# DEVELOPMENT SERVICES

## SITE PLAN REVIEW AND APPEARANCE BOARD

325 Shoppes on Atlantic Ave

Meeting	File No.	Application Type
July 27, 2022	2022-131-SPM-SPR-CL3	Class III Site Plan Modification with Waiver
Applicant	Property Owner	Authorized Agent
325 East Atlantic Avenue LLC	325 East Atlantic Avenue LLC	Gary Eliopoulos, GE Architecture, Inc.

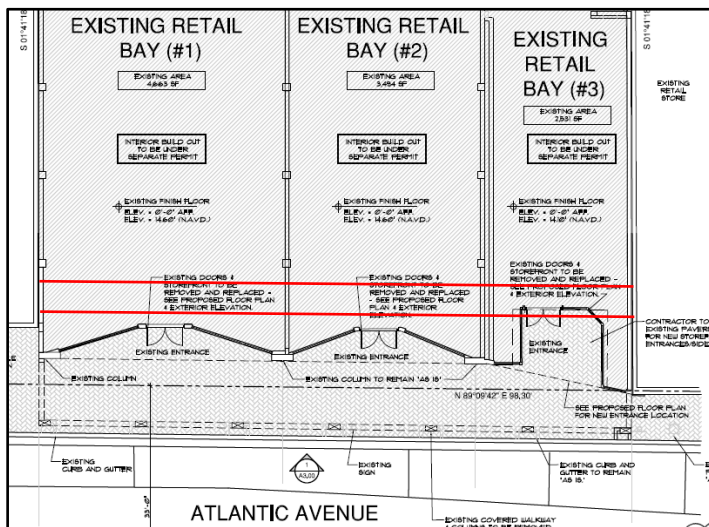
The removal of the arcade changes the applicable minimum setback requirements. The proposed changes to the recessed entries require a waiver to the minimum front setback requirements as they result in an increased encroachment into the front setback area.

The existing front setback varies from 0-feet to approximately 13 feet, 4 inches; these dimensions are prior to the required 2-foot right-of-way dedication. Post-dedication, a portion of the building (in the current configuration) will be within the public right-of-way and the deepest point of the facade recesses are set back 11 feet, 4 inches. The CBD front setback is a minimum of 10 feet to a maximum of 15 feet, while providing a minimum 15-foot wide streetscape.

Note: The Palm Trees in the rendering are not proposal; shade trees are required and proposed along the front.

Existing plan

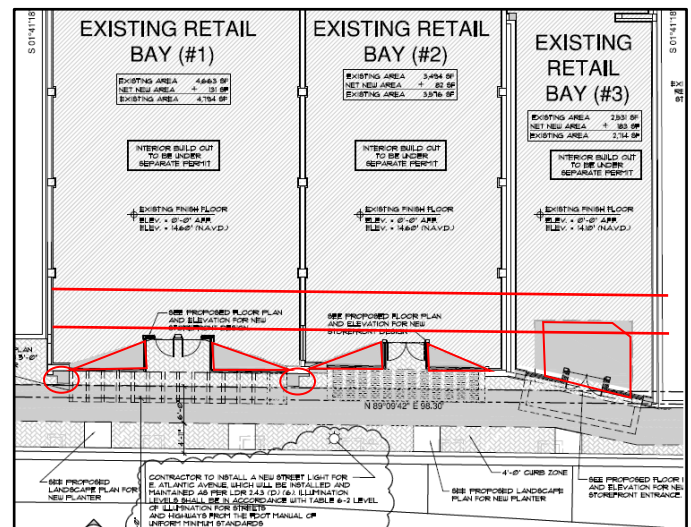
After the 2-foot right-of-way dedication, the setback variation between the existing condition and proposed modifications are:

**Existing Front Setback:** 0' to 11'-4"

**Proposed Front Setback:** 0' to +/- 7'-9"

The red lines in the graphic below illustrate the required 10-foot to 15-foot setbacks from the ultimate right-of-way line, as a 2-foot right-of-way dedication is required as part of the request. The red circles and outlined areas show where the non-conformity is being increased.

Pursuant to LDR Section 1.3.5(B)(1), "A nonconforming structure shall not be altered or enlarged in any way which increases its nonconformity, vertically or horizontally..." Therefore, waiver is required adjust the front façade position as proposed.
